**Environmental Evaluation Report**

**Copper Flat Project**

**Prepared for**  
**New Mexico Energy, Minerals and**  
**Natural Resources Department**  
**Mining and Minerals Division**  
**Santa Fe, New Mexico**

**November 19, 1997**

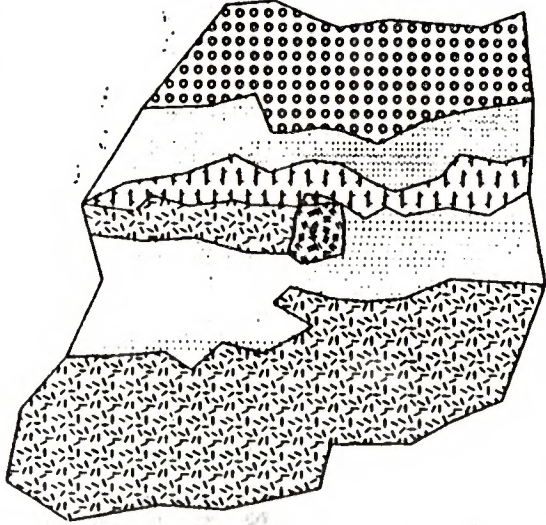
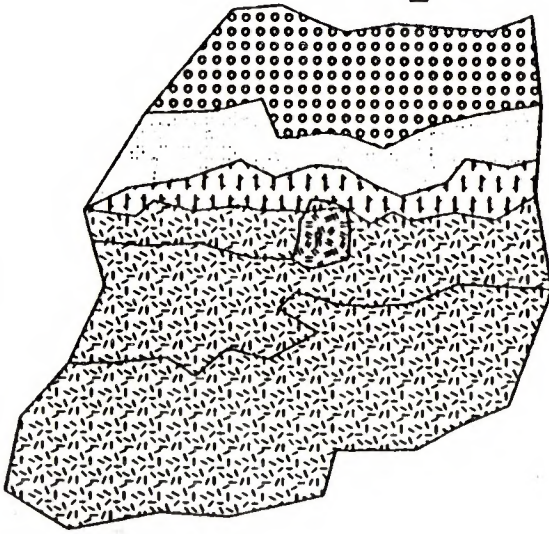
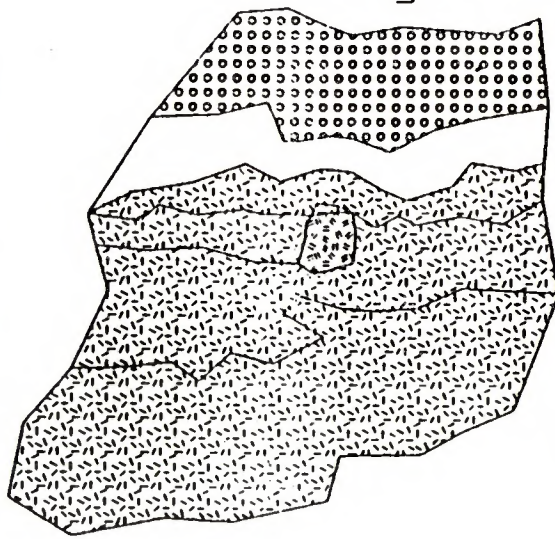
next 800 feet of saturated material, and model layer 3 represents the remaining 1,000 feet of saturated material (Figure 2-2).

Figure 2-3

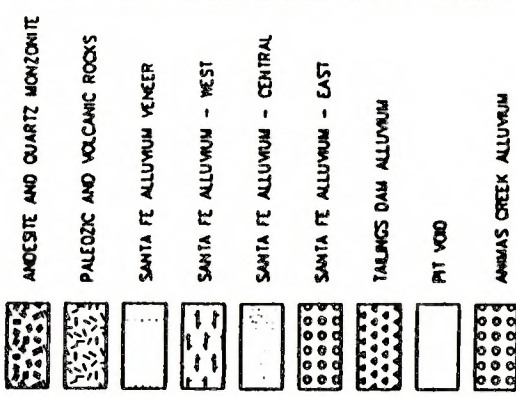
ABC apportioned the Santa Fe alluvium in their regional model into 5 distinct zones (Figure 2-3). Each zone has different hydraulic characteristics. Of critical importance is the zone referred to as Santa Fe alluvium east, since the production wells are located in this zone. The hydraulic conductivity applied in this zone has a significant impact on simulation results, and is critical in the determination of impacts to surface water bodies such as the Rio Grande.

This approach is not supported by aquifer tests conducted at the site or by previous researchers and modeling studies. In addition, since groundwater flow in the Santa Fe alluvium is predominantly from west to east, the hydraulic conductivity in the north-south direction is not a critical factor for the steady-state model calibration. In order to verify the appropriateness of this parameter using model calibration, a calibration that involved significant north-south groundwater flow components (such as a cone of depression formed by pumping wells) would have to be conducted. This type of calibration was not conducted by ABC.

Figure 3-1

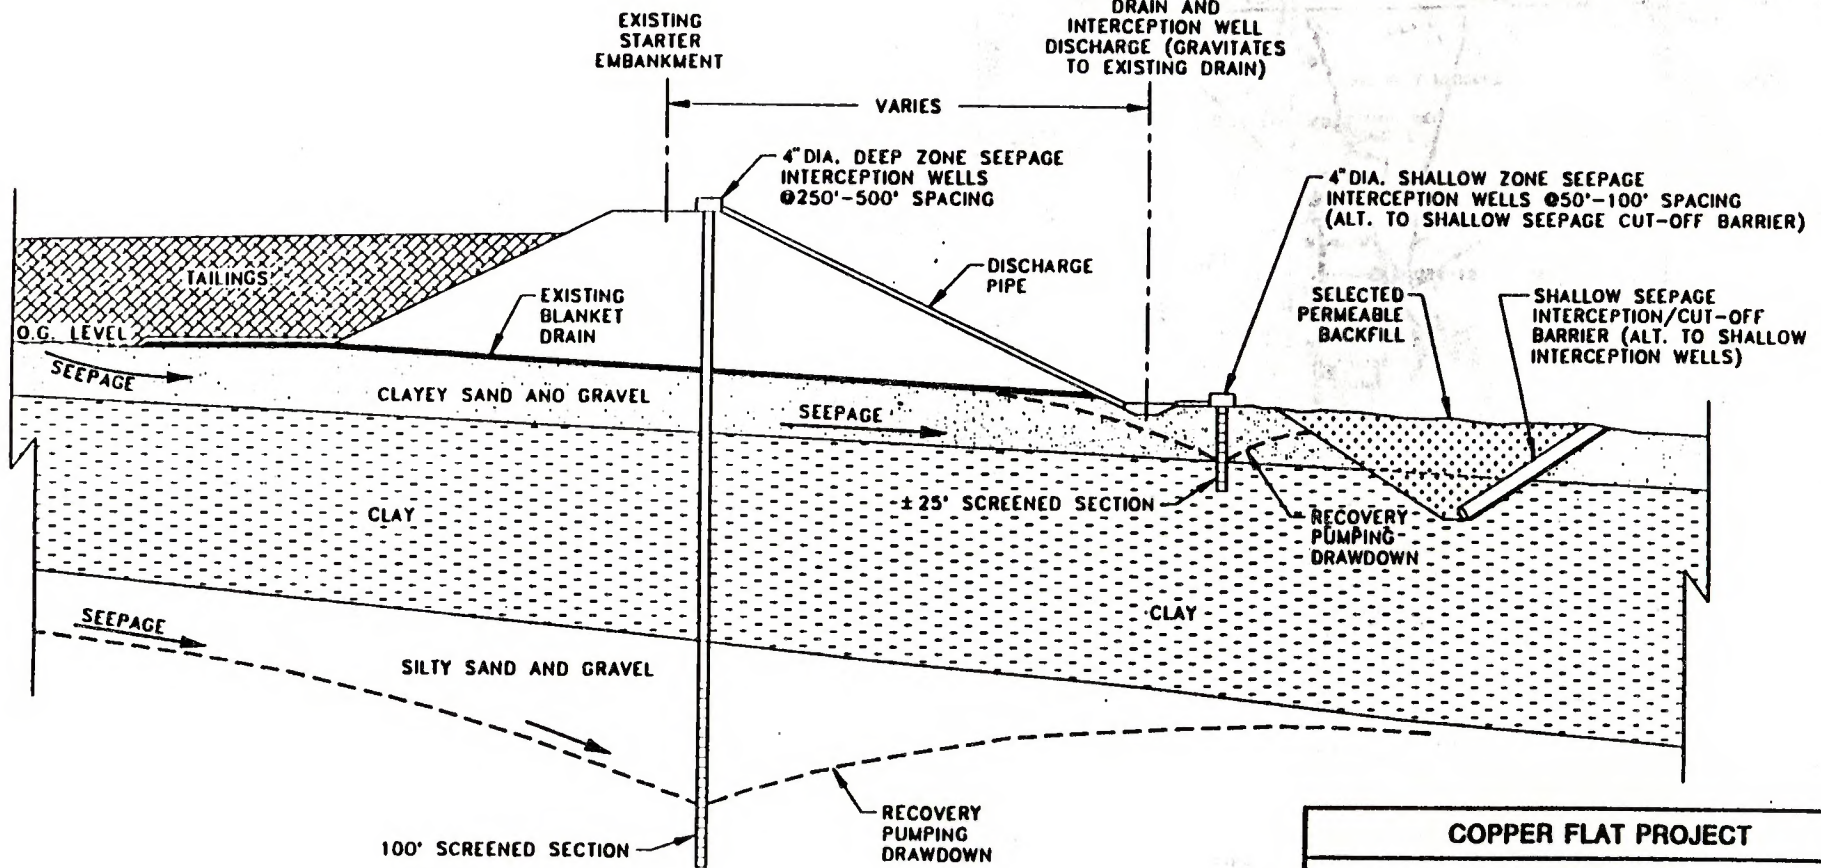
Further, monitor well NP-3, completed at a total depth of 79.3 feet bgs, would be considered a shallow well as defined by SRK (1995, Section G.3.4). However, this well maintains a static head representative of lower-zone head conditions. During the test, over 14 feet of drawdown were measured in NP-3, indicating that the hydraulic separation provided by the clay unit is much less near the center portion of the starter dam (Figure 3-1).

The hydraulic conductivity values used in the numerical modeling are poorly supported. For example, it is unclear on what basis the unsaturated hydraulic conductivity values were divided into the three zones shown on Figure 3-1 (Figure 2 in Appendix L). Local hydraulic conductivity data do not support this zonation. For example, based on SHB's geotechnical evaluation (SHB, 1980), the borings advanced within the impoundment footprint had similar lithologic character as the sediments east of the starter dam to the investigated depth of 75 feet bgs, suggesting there is little basis for varying hydraulic conductivity in the lower zone. Since there is no obvious difference in the grain-size distribution throughout the lower zone based on available well logs, it seems the model would be best run with actual measured local values of hydraulic conductivity determined from the pumping test conducted immediately downgradient of the starter dam. However, the area west of the impoundment should be assigned a lower unsaturated hydraulic conductivity based on the andesite present at the GWQ94-6 location.

Figure 3-2

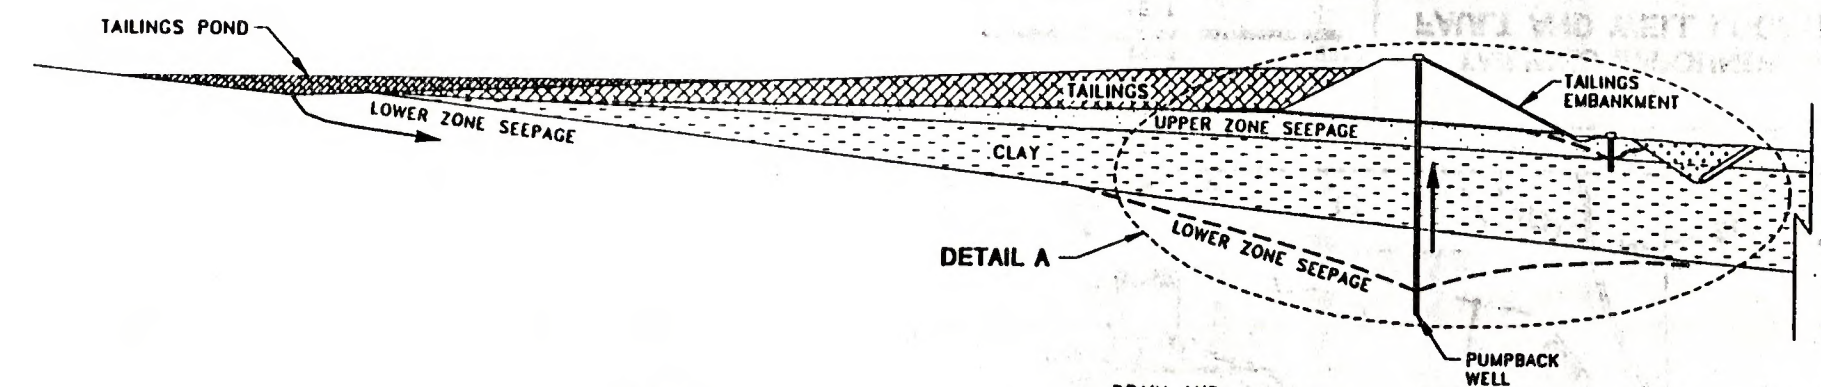
Based on the available data, SRK developed a conceptual model for groundwater flow beneath the impoundment, which consists of two distinct groundwater zones that discharge toward the east (Figure 3-2). The first zone, referred to as the lower zone, consists of clayey and silty sands, and gravels of the Santa Fe Group. Groundwater within the lower zone is confined under a clay unit which, from its western edge, dips and thickens toward the east. The western edge of the lower zone is located approximately 200 feet west of the starter dam. The second zone, referred to as the perched zone, consists of recent alluvial materials located above the confining clay. The perched zone of groundwater flow was likely created during operation of the north cell in the early 1980s by Quintana Minerals (SRK, 1995).

Water from the tailing is designed to drain at a maximum rate of 1,400 gpm to the underlying materials in order to enhance tailing consolidation, ensure stability of facility, and expedite reclamation of the facility (SRK, 1996). The proposed seepage collection system consists of a series of collection wells and trenches designed to address seepage (1) beneath the starter dam, (2) perched above a clay layer present at roughly 20 feet bgs, and (3) within deep groundwater confined beneath the clay layer. Figure 3-2 shows SRK's conceptual design for seepage control for the tailing impoundment.

Several sections of the hydrogeologic report provide supporting calculations for the proposed pumpback system for the deep groundwater zone (SRK, 1995). DBS&A has identified several problems with both the analytical and numerical analyses use to design the proposed collection system. Within the application materials, seepage collection for the upper perched zone is not discussed in no more detail than what is given above. A discussion of the problems and potential ramifications of the analyses for the deep zone collection system are provided below.
